ADDENDUM NO. 1

Date of Addendum: October 13, 2015

PROJECT NAME: Rehabilitation of Distribution Pumps, Motors, Valves, Piping and  
Pump Station Buildings at Various Facilities - Package B

PROJECT NO: WBS No. S-001000-0046-4

MISCELLANEOUS  
MECHANICAL DETAILS  
SHEET 2 OF 3  
MECHANICAL

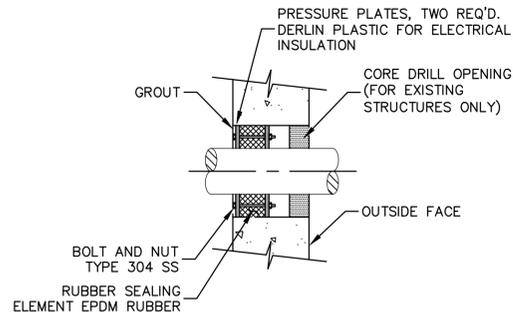
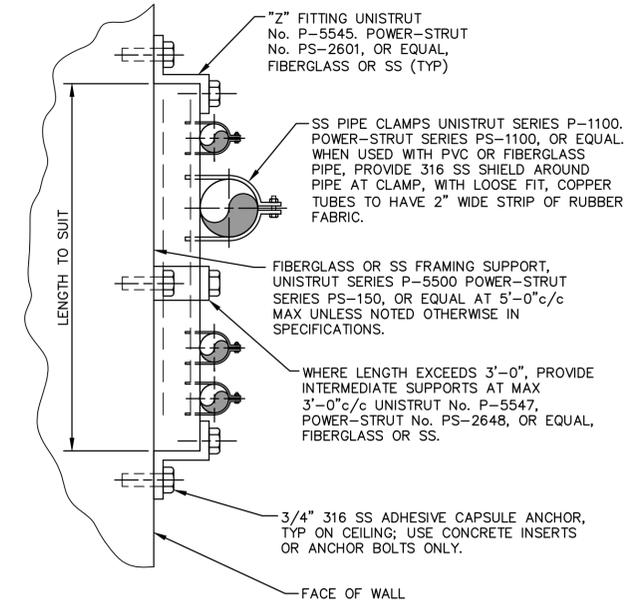
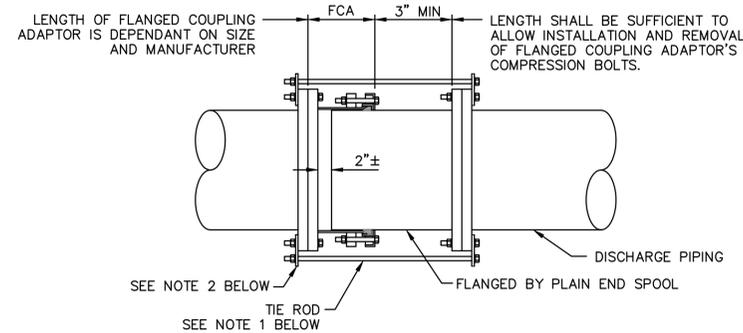
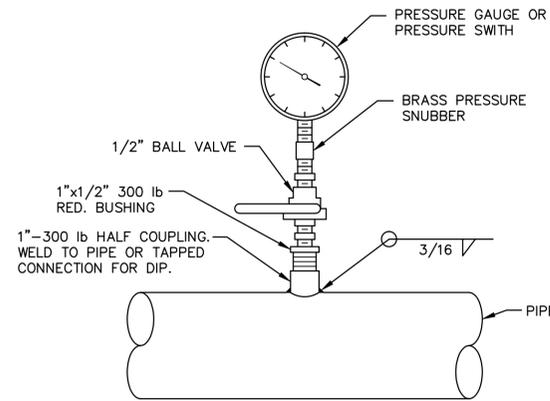
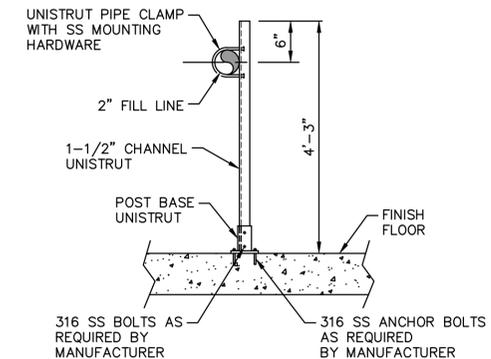
6. Delete Sheet 11 (STD-M-2), Miscellaneous Mechanical Details Sheet 2 of 3, and replace with revised Sheet 11 (STD-M-2).
7. Delete all notes on Sheet 19 (111 #2-M-1), Booster Pumps and Piping Demolition Plan.

REHABILITATION OF PUMPS,  
MOTORS, VALVES, PIPING &  
BUILDINGS AT VARIOUS FACILITIES  
PACKAGE B  
DISTRICT 111 No.2 WATER PLANT  
BOOSTER PUMPS AND PIPING  
PROPOSED  
PLAN  
MECHANICAL

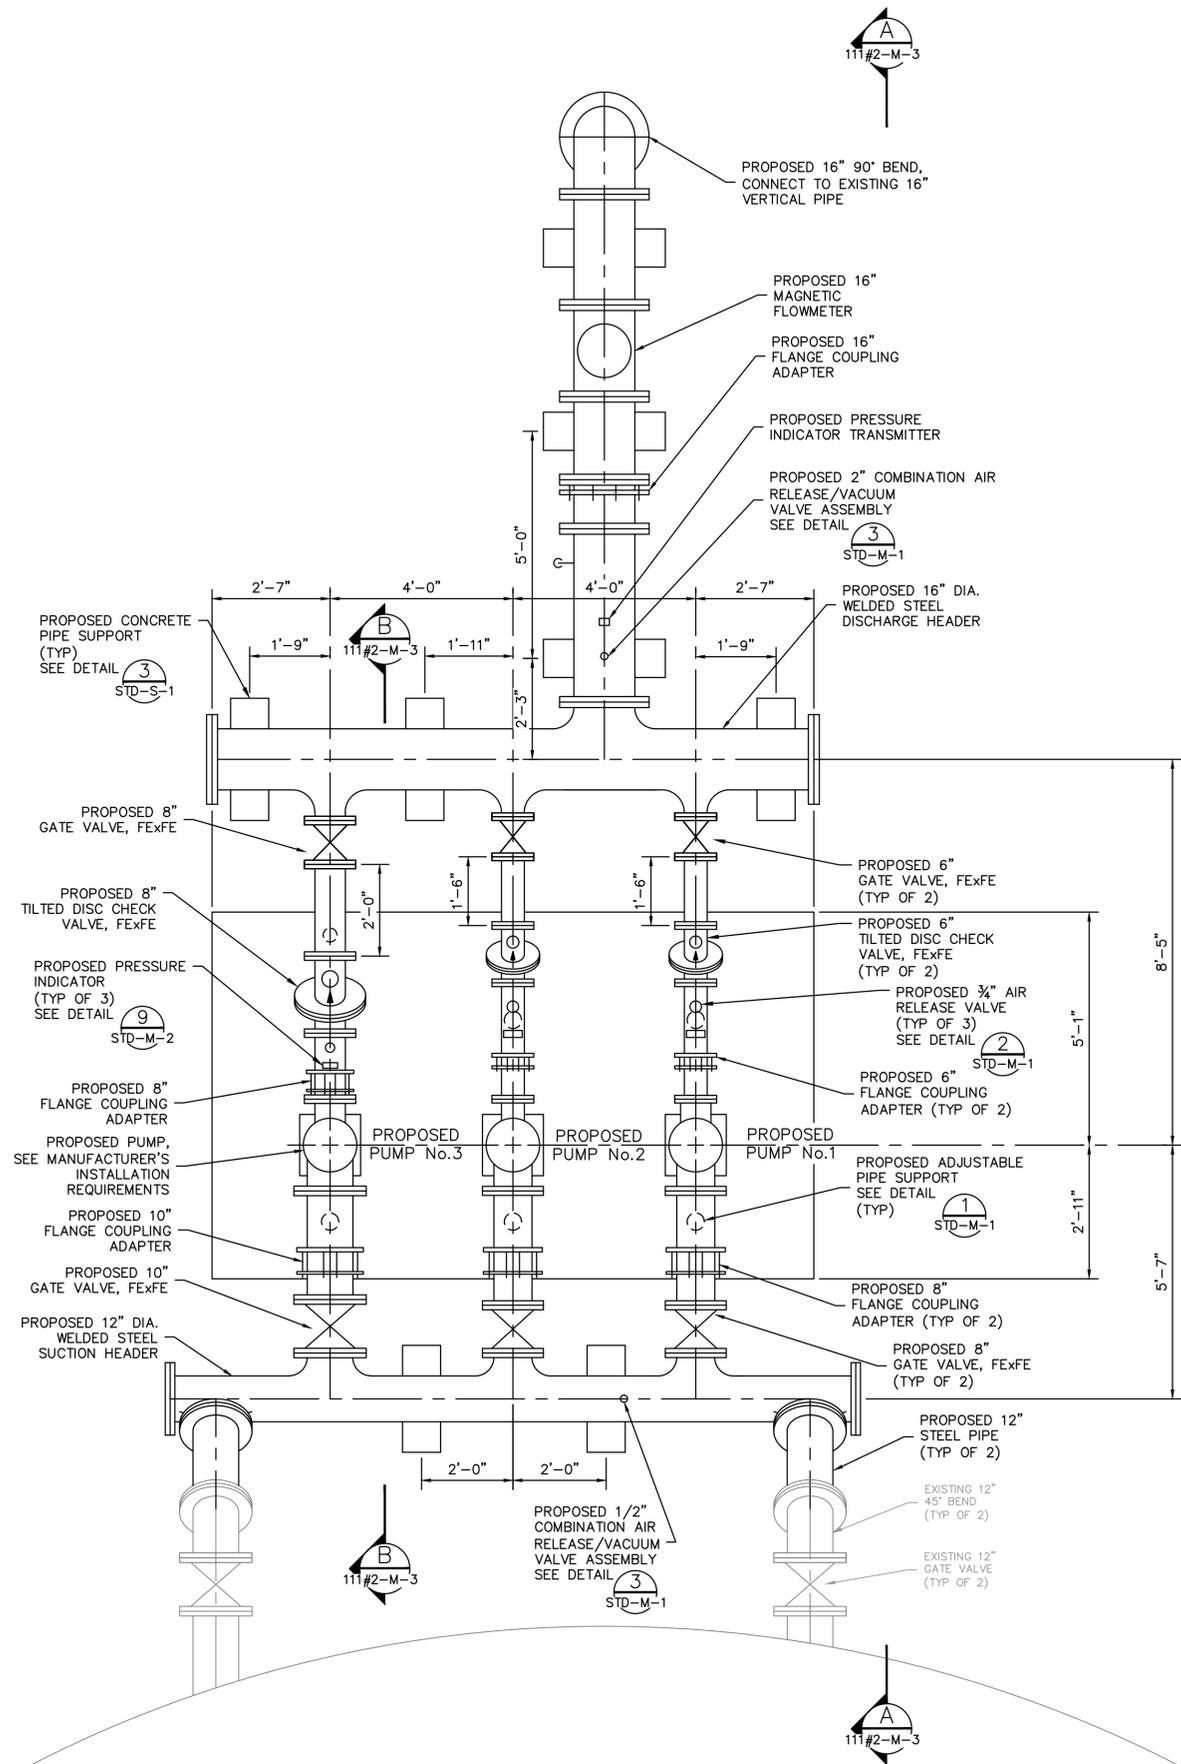
8. Delete Sheet 20 (111#2-M-2), Booster Pumps and Piping Proposed Plan, and replace with revised Sheet 20 (111#2-M-2).
9. Delete Sheet 45 (WH#3-M-2), Booster Pumps and Piping Proposed Plan, and replace with revised Sheet 45 (WH#3-M-2).

WH#3-E-2

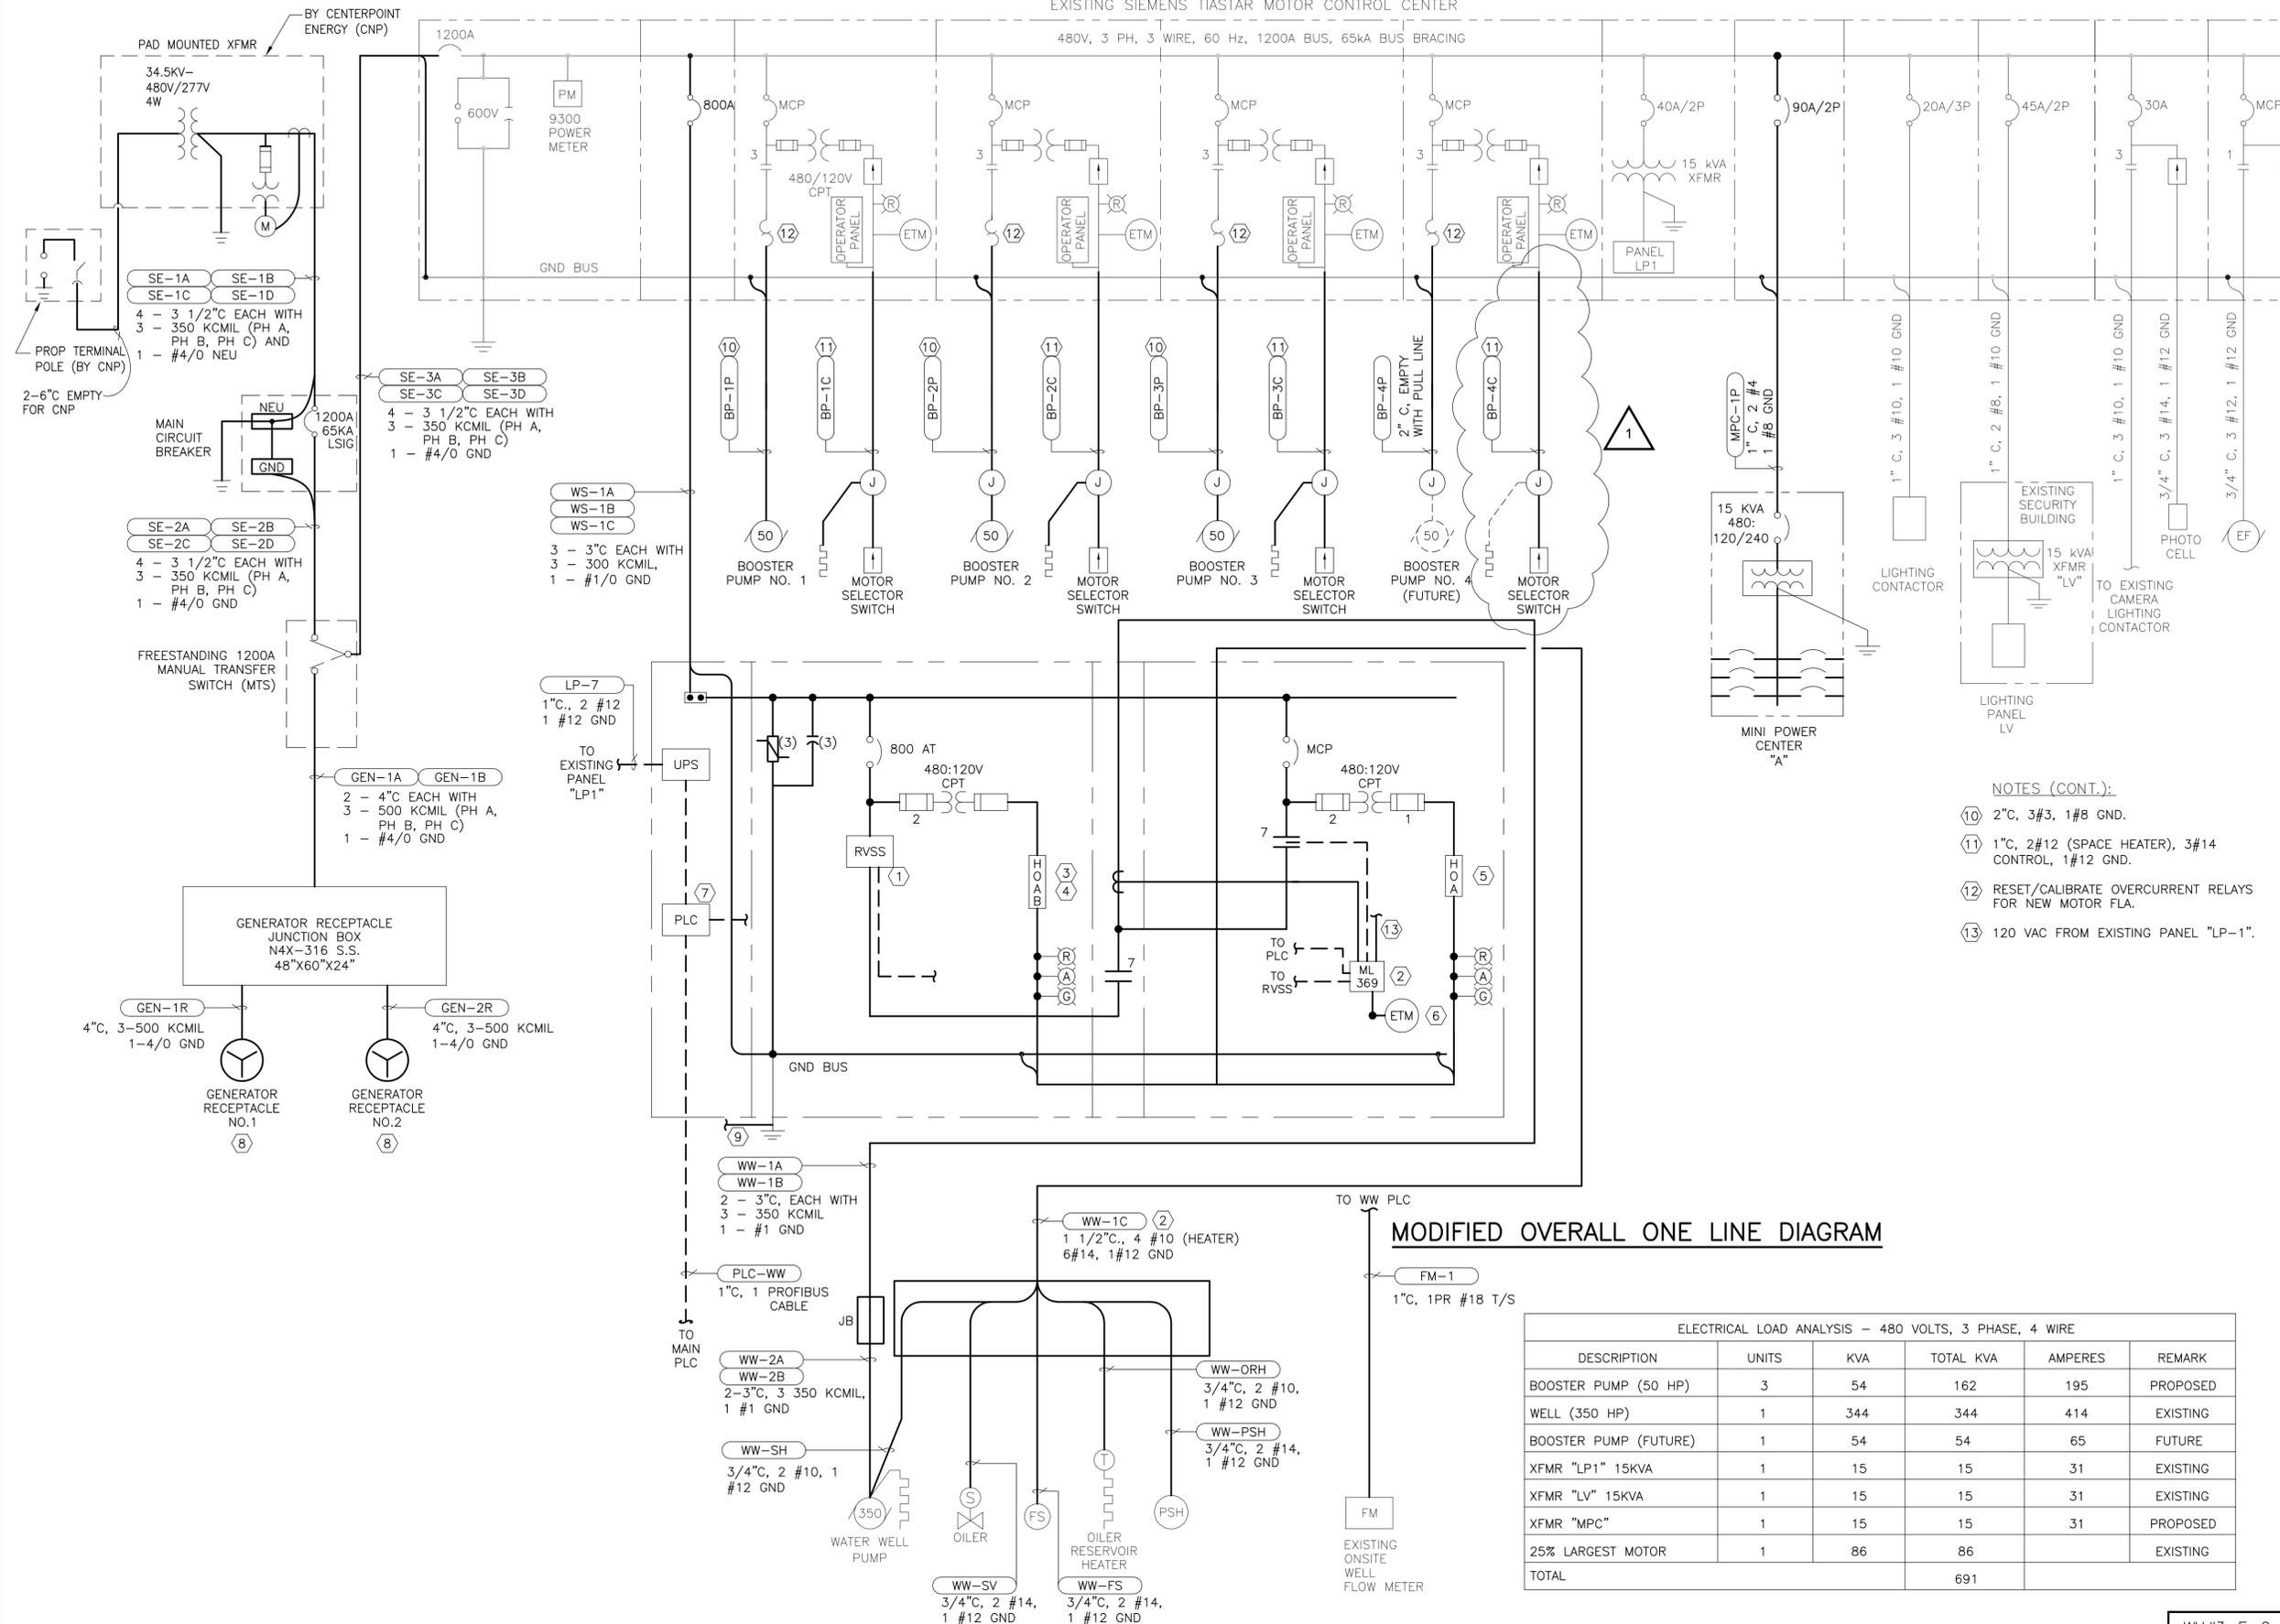
10. Delete Sheet 50 (WH#3-S-3), Foundation for Proposed Booster Pump Area, and replace with revised Sheet 50 (WH#3-S-3).
11. Delete Sheet 57 (WH#3-E-2), Modified One Line Diagram, and replace with revised Sheet 57 (WH#3-E-2).
